Access Compliance Report

Public Rights-of-Way

(Curb Ramps)

Intersection ID: 29558	Main Street: BAYSE_CT	Cross Street: MCGLOUGHLIN_WAY_CT	Location: SW
ADA ID: FB38804A9D93	Ramp Type: PerpDiag	Initial Pass/Fail: Fail	Overall Compliance: No
		Severity Score: 21.25

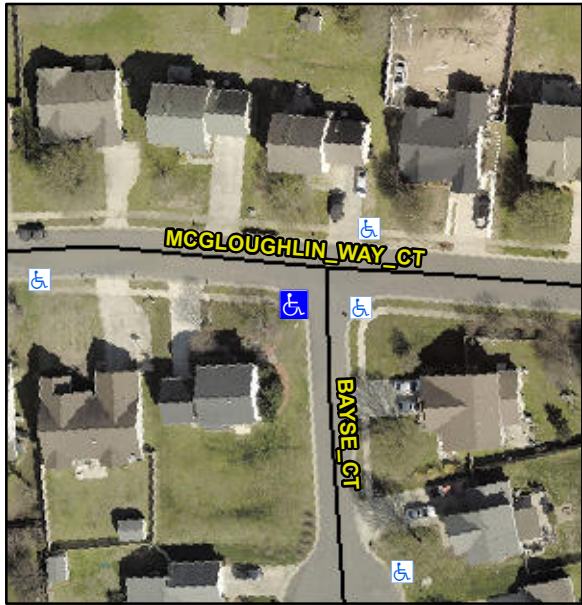
Codes/Mitigation Info/Possible Solution		Field Measurements/Component Compliance					
	Possible Solutions:						
	Remove & Replace Curb Ramp With Two New Directional Ramps or Equivalent.	N/A	Ramp Length (in)	50.0	No	Ramp Slope (%)	9.5
		No	Ramp Width (in)	45.5	Yes	Ramp XSlope (%)	1.6
		N/A	Flare Type LT	N/A	N/A	Flare Type RT	N/A
		N/A	Flare Slope LT (%)	N/A	N/A	Flare Slope RT (%)	N/A
		N/A	Flare Traversable LT?	N/A	N/A	Flare Traversable RT?	N/A
		N/A	Landing Length (in)	N/A	N/A	DWS Provided?	N/A
		N/A	Landing Width (in)	N/A	N/A	DWS Contrast?	N/A
		N/A	Landing Slope (%)	N/A	N/A	DWS Length (in)	N/A
		N/A	Landing X Slope (%)	N/A	N/A	DWS Full Width?	N/A
<p>Surveyor Notes:</p> <p>N/A</p> <p>PROW/ADA:</p> <p>Not Found, R304.5.1, R304.2.2</p>		N/A	Landing Curb? (Y/N)	N/A	N/A	DWS Offset (in)	N/A
		N/A	Shared Landing?	N/A			
		N/A	Gutter Ponding?	N/A	N/A	Gutter Slope (%)	N/A
		N/A	Gutter Lip Ht (in)	N/A	N/A	Gutter X Slope (%)	N/A

N/A	Painted X Walk1?	No	N/A	Painted X Walk2?	No
			X Walk 1 Direction	To E		X Walk 2 Direction	To N
		N/A	X Walk 1 Width (in)	N/A	N/A	X Walk 2 Width (in)	N/A
			X Walk 1 Slope (%)	0.3		X Walk 2 Slope (%)	1.0
			X Walk 1 X Slope (%)	0.4		X Walk 2 X Slope (%)	0.3
		N/A	Ramp inside XWalk1?	N/A	N/A	Ramp inside XWalk2?	N/A
			Road Slope (%)	0.4	N/A	Clear Space?	N/A
			Road X Slope (%)	1.0	N/A	Clear Space to XWalk (in)	N/A
		N/A	Any Obstructions?	N/A	N/A	Storm Grate/Utility Hazard?	N/A
			Obstruction Type			Storm Grate/Utility Type	
				N/A			N/A
					Yes	Surface Condition? (G/P)	Good
